211813 CFAA

## Modification 7 Precinct Village and Carpark (SSD-9835-Mod-7)

### Technical Note on Flooding in Response to DPE Comments

Figure 14. Proposed Stormwater for Flood Mitigation

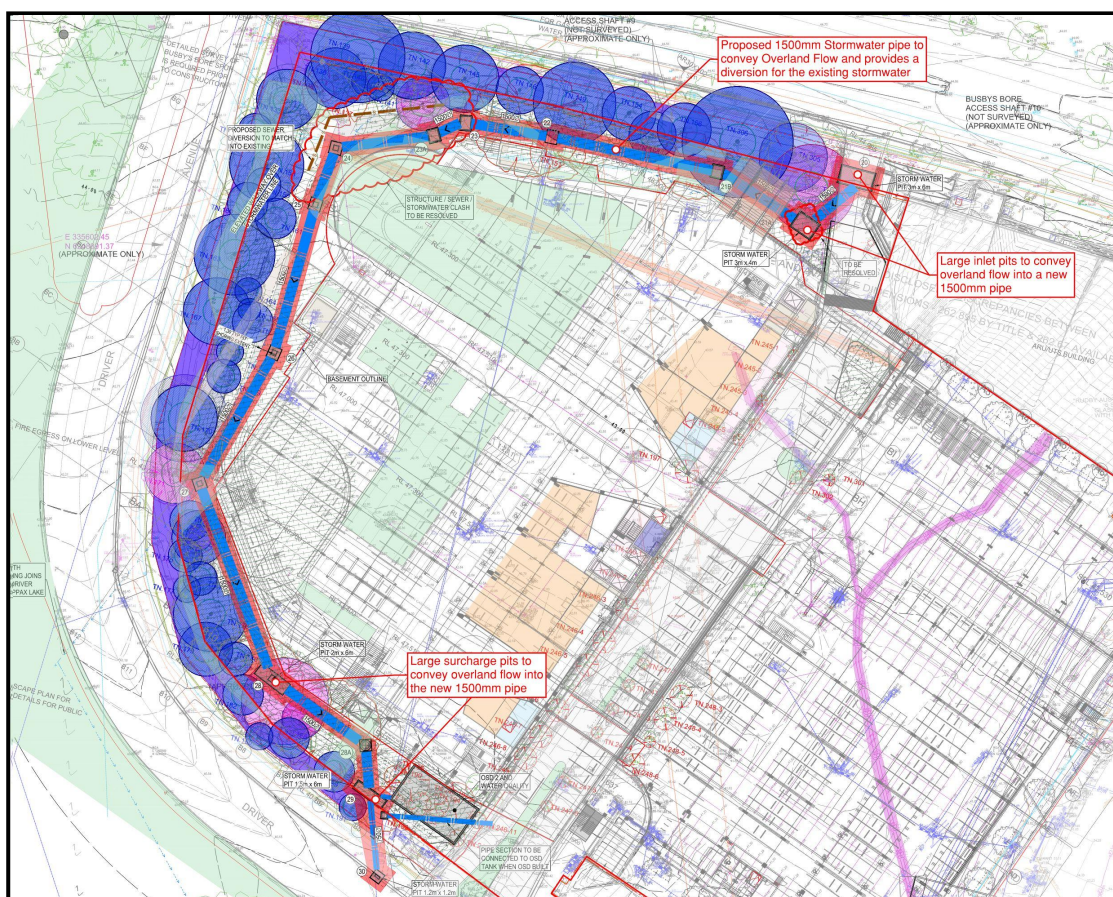
EES does not agree that the required design solutions to manage and mitigate the impacts of flooding should be delayed until the detailed design of the proposal is finalised.

It is standard practice to provide evidence that the design solution achieves the required objectives. EES considers that an updated report should be produced, documenting the new design solution, and including updated figures, is required to appropriately assess the potential for and severity of flood impacts.

Section 4.0 provides details of the proposed flood mitigation design solution and confirms that there are no significant impacts associated with the development. Additional figures have also been incorporated throughout this report to show the existing and proposed flooding together with any impact associated with the development.

The current design incorporates a new 1.5m diameter pipe that runs north and west of the western car park. Overland flow approaching the access road from Moore Park Road is conveyed into the 1.5m pipe by two large inlet pits located within and adjacent to the new access road off Moore Park Road. This option has two surcharge pits to the south of the western car park. The surcharge pits allow the piped flow to be conveyed as overland flow towards Driver Avenue and Kippax Lake, replicating the flood behaviour prior to development, refer to Figure 14. The current design no longer includes flood storage tanks.

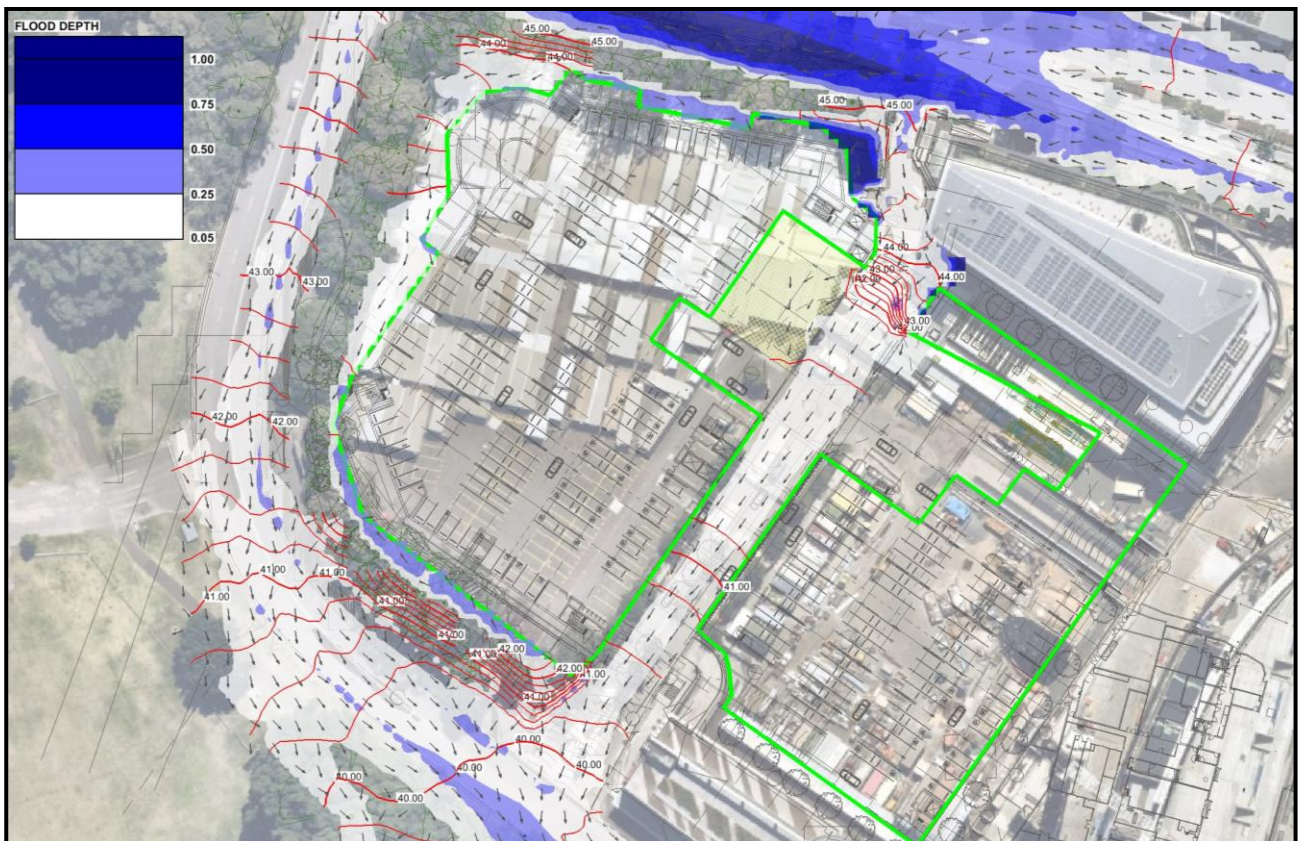
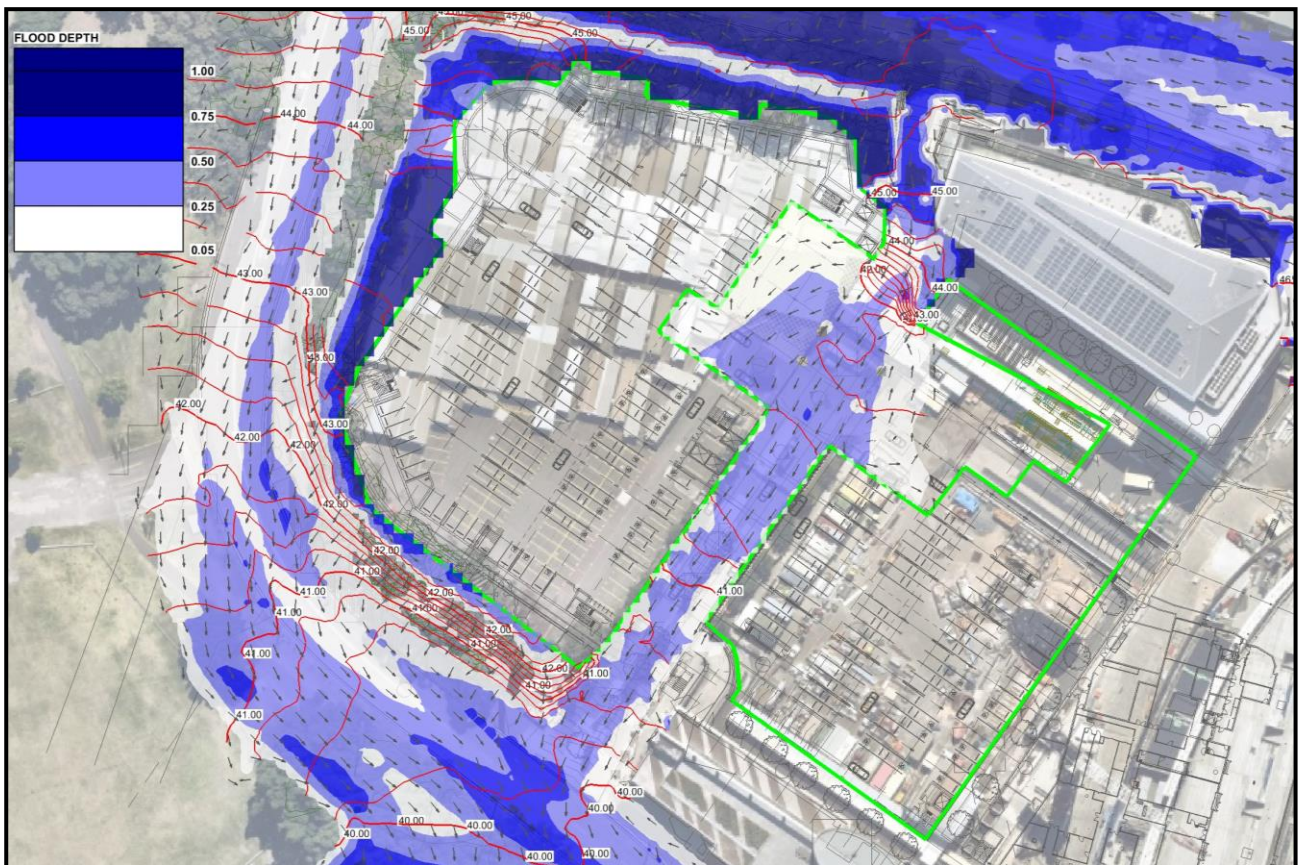
- there are only three figures presented in Appendix G, presumably showing hazard. The RtS states afflux figures were provided, but they are not available at Appendix G. Figures as per the original report should be updated, including depth/level and afflux

Additional figures have been included in section 4.0 that show flood levels, depths, hazard and afflux associated with the proposed development.

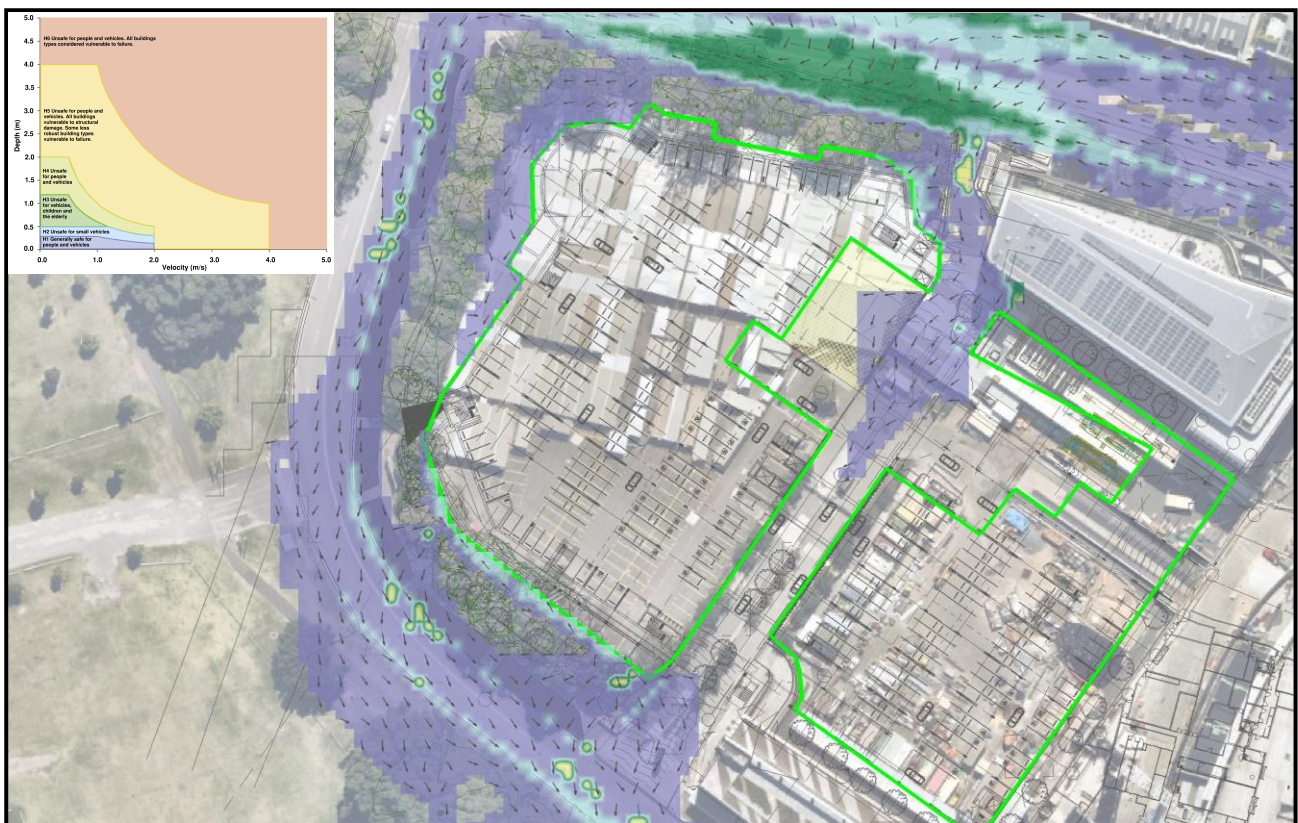
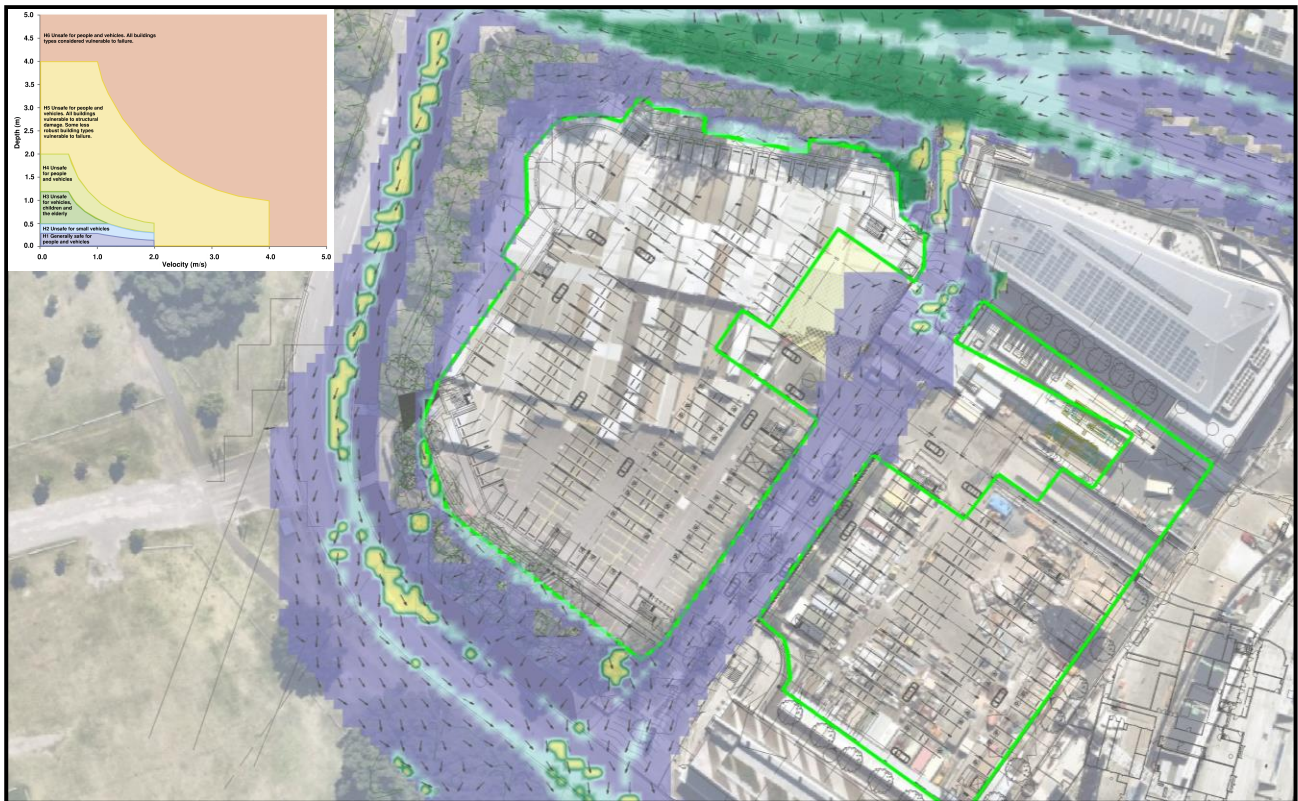
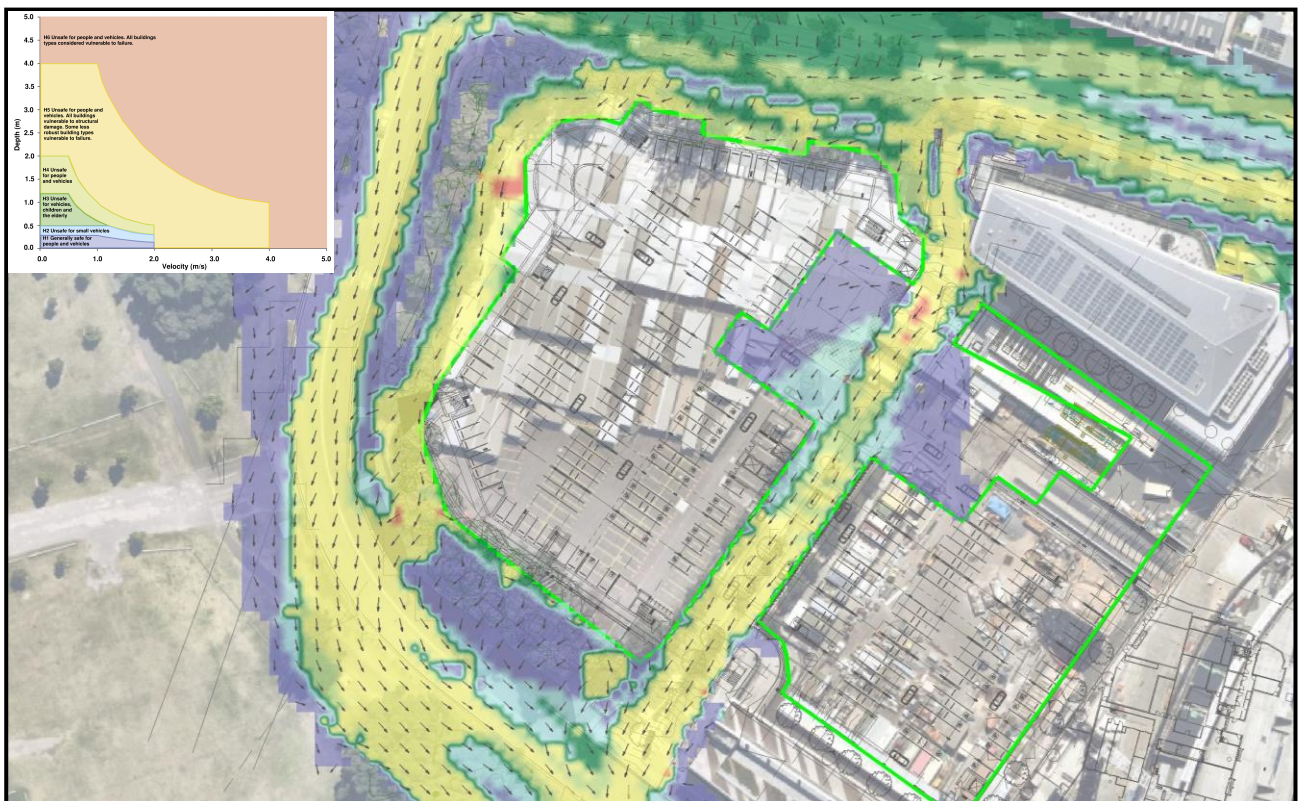
- the RtS does not demonstrate that “no worsening of hazard on the central driveway” has been achieved, but in fact indicates the opposite. EES therefore strongly recommends that clear documentation is provided to justify this conclusion.

Section 4.0 confirms that the hazard across the precinct is similar to the existing condition, with a slight improvement in hazard along the central driveway in the 5% and 1% AEP events.

This current design reduces the overland flow along the access road to a manageable flood hazard (Hazard Category H1 – safe for vehicles and pedestrian) and flood depth in the 5% and 1% AEP events which is no worse than the existing condition (figures 6 and 7). The proposed flood hazard along the central access road is high (H5) in the PMF which is similar to the existing condition (figure 8), but the hazard generally lower across the wider precinct compared with existing. Refer to figures 15, 16 and 17 for the 5% AEP, 1% AEP and PMF flood levels and depths, and figures 18, 19 and 20 respectively for flood hazard.
